STAFF REPORT:
DE NOVO HEARING ON APPEAL

| APPEAL NO.: | A-1-MEN-01-056 |
| APPLICANTS: | Gale and Dorothy Williams |
| PROJECT DESCRIPTION: | Construction of a 2,460 square-foot, 23.85-foot-high, single-family residence, with a 632-square-foot attached garage/mechanical room, a septic system, connection to an existing private water system, driveway, concrete walkway, and wooden decks. |

LANDSCAPE PLAN
 NO SCALE

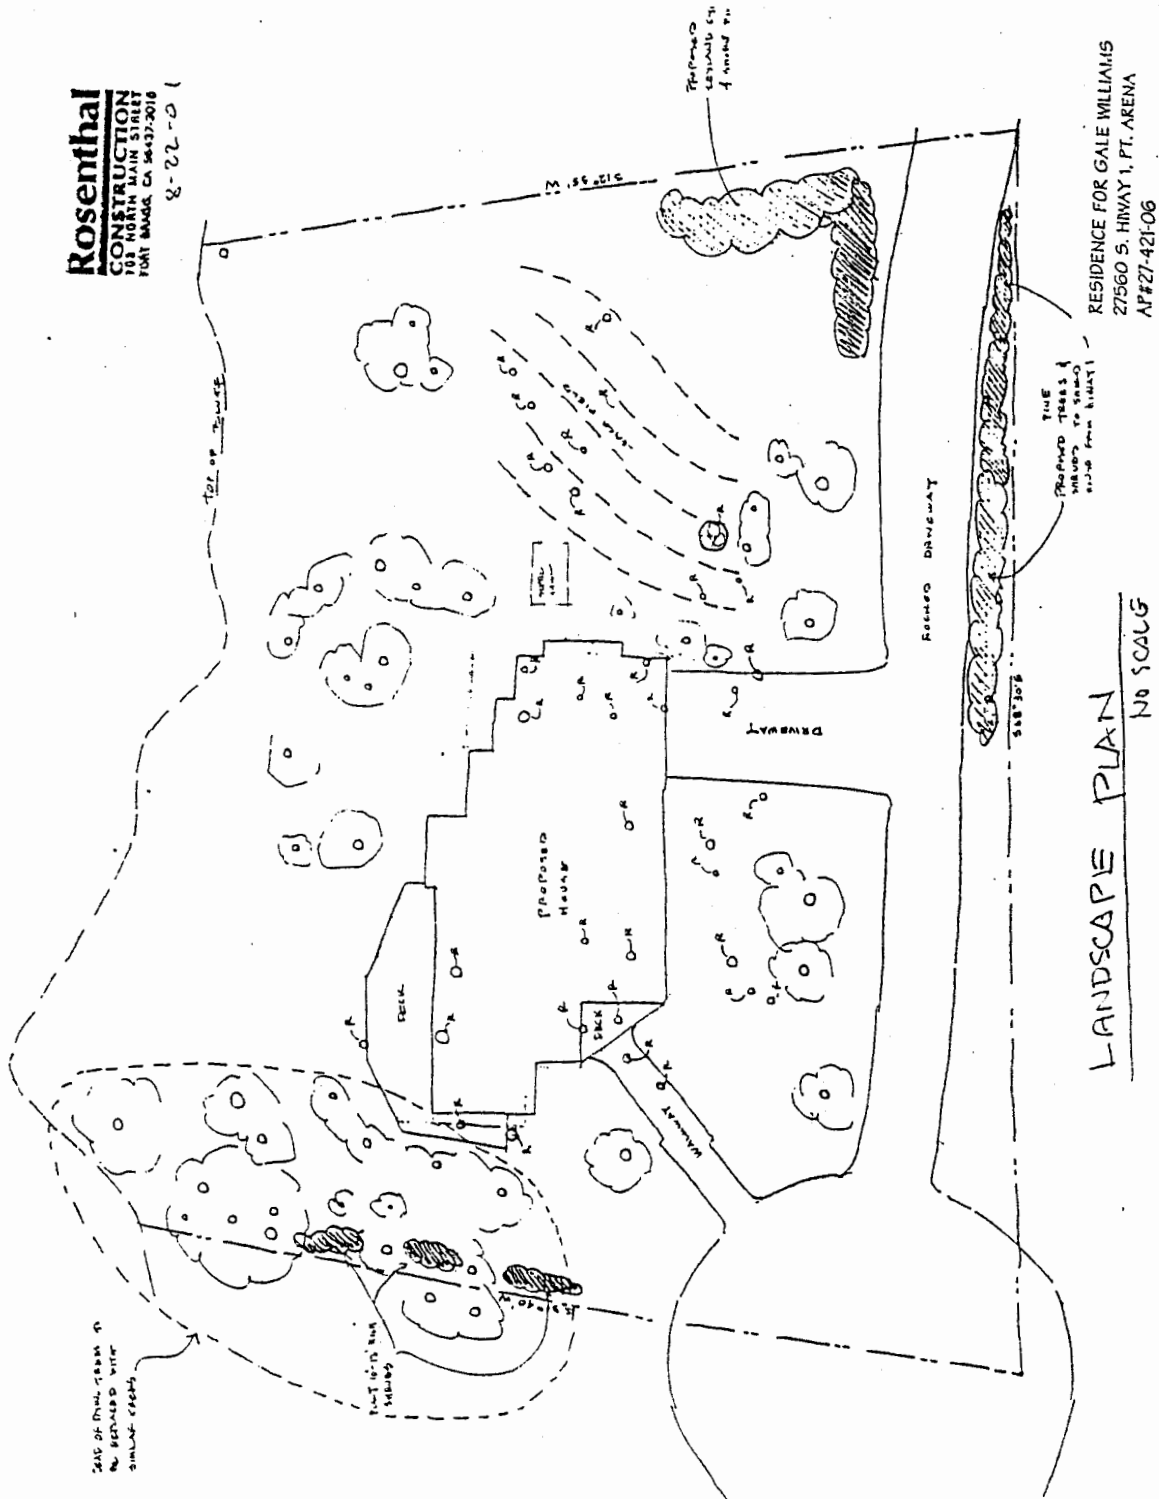
Special Condition of Approval #5 states: "Prior to the issuance of the CDP, the applicant shall submit a final landscape plan [based on the preliminary plan] submitted at the hearing."

The "landscaping plan" submitted (late) with the plans is incomplete. It does not claim to actually accomplish an effective screening of the development. It was truly called a "preliminary plan." There is no security to the public that the plan will actually mature in a way that will create a long-term and effective buffer to hide the bulk, lights, height, and colors of the structure.

There are no performance standards submitted which would show how the landscape would screen the house. Only the most sketchy notes are included to specify the sizes or kinds of trees or bushes to be planted.

1. Landscape Plan Revisions
 - a. The landscape plan shall be revised to eliminate the use of English holly (*Ilex aquafloium*). A suitable substitute shall be used in its place. Only native and/or non-invasive plant species appropriate for the growing conditions of the site shall be used in the landscaping plan.

- b. Five additional 5-gallon sized trees from the approved landscaping plant list and five additional wax myrtle shrubs shall be planted in well-distributed locations along the southern bluff-edge portion of the property to augment the long-term effectiveness of the visual screening currently provided by existing trees.

- c. The landscape plan shall include a planting schedule, which ensures that all planting shall be completed within 60 days after completion of construction.
